RE: Comments for the Record  
Cayuga Operating Company, LLC  
SPDES Permit NY0001333  
DEC No. 7-5032-00019-00004  
228 Cayuga Drive, Lansing, New York

## Technical Findings

Figure 1  
Potentiometric Surface Diagram (Modified)  
August 2006

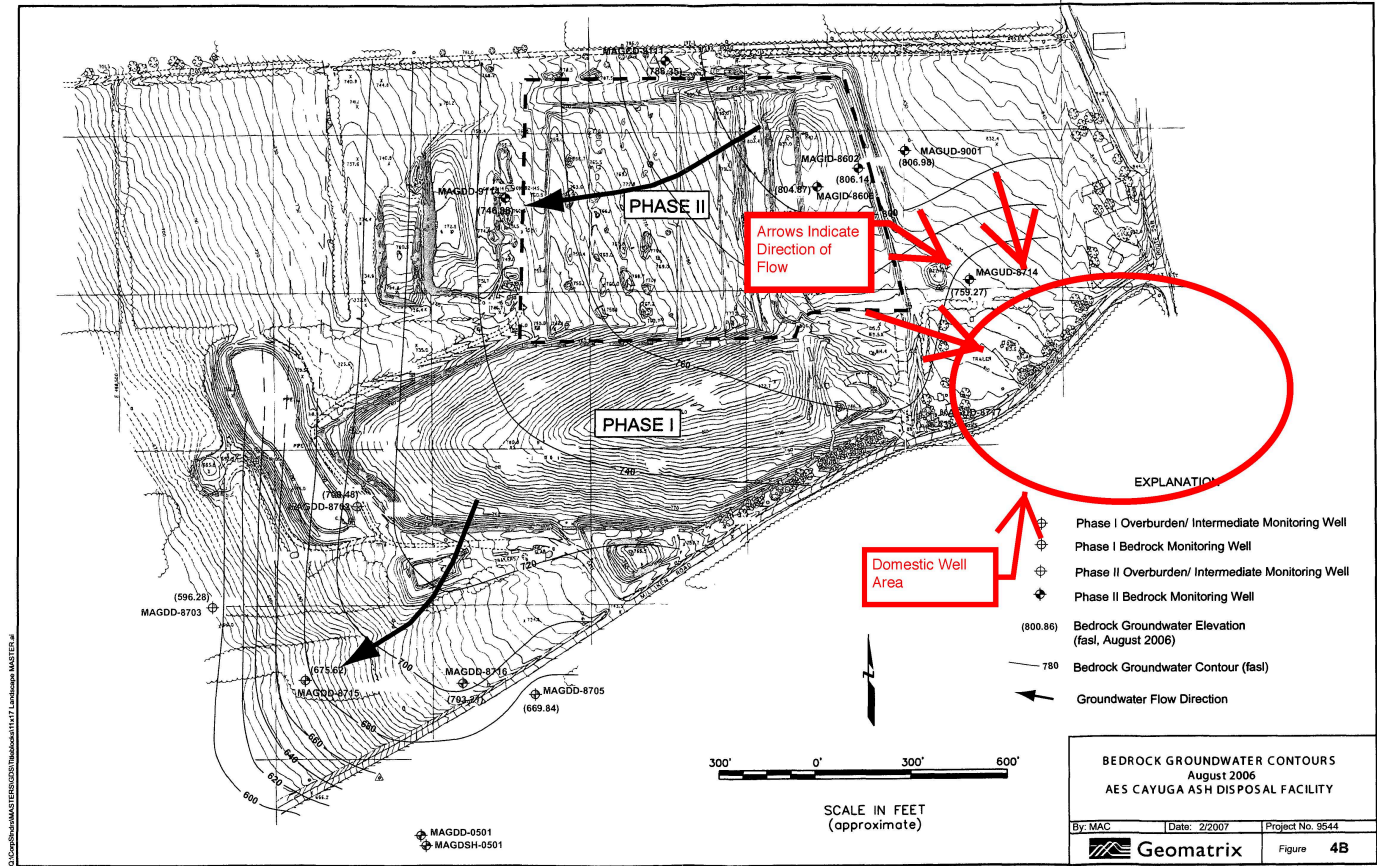
22. Although groundwater flow diagrams produced by Cayuga have illustrated a south-southeast bedrock groundwater flow direction<sup>5</sup> *towards residential properties with domestic water supply wells*, there is no indication that Cayuga has ever sampled those wells. See attached **Figure 1**.

60. Cayuga’s conclusion in 2010 that MAGUXX-8303 and MAGUXX-7712 are “upgradient” and therefore do not represent groundwater flowing from beneath the landfill is not based upon fact or their own data. When the monitoring program at the landfill included more wells in that area (e.g. 2006, before wells were destroyed to construct a portion of the Phase 2 landfill), those bedrock wells are clearly hydraulically *downgradient* of both Phase 1 and Phase 2<sup>16</sup>. See attached **Figure 1**.

68. An independent search in January 2015 for water well users completed by Dr. John Dennis – Environmental Planner and Member of the Tompkins County Environmental Review Committee – identified at least 25 water wells within an approximate 1-mile radius of the landfill.
69. That search identified three water wells within approximately 1,000 feet of the southeastern corner of the landfill. See **Figure 1**.

**Figure 2**  
**Potentiometric Surface Diagram**  
**June 2012 Bedrock Aquifer**

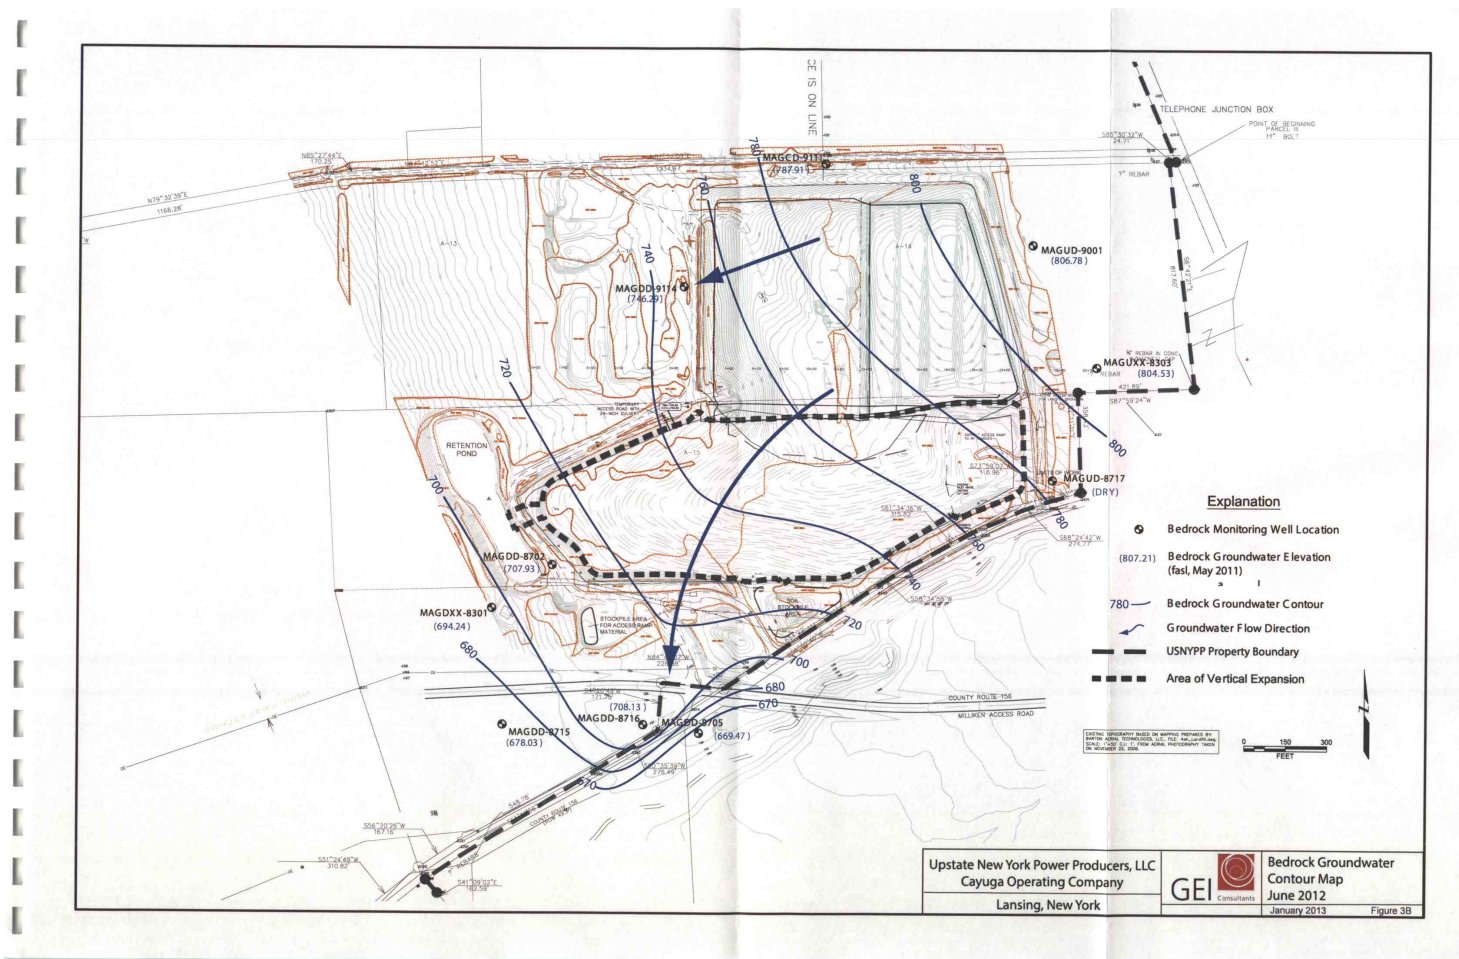
23. Cayuga’s most recent Environmental Monitoring Plan (2014) illustrates a dominant direction of flow instead towards the west-southwest. See attached **Figure 2**.
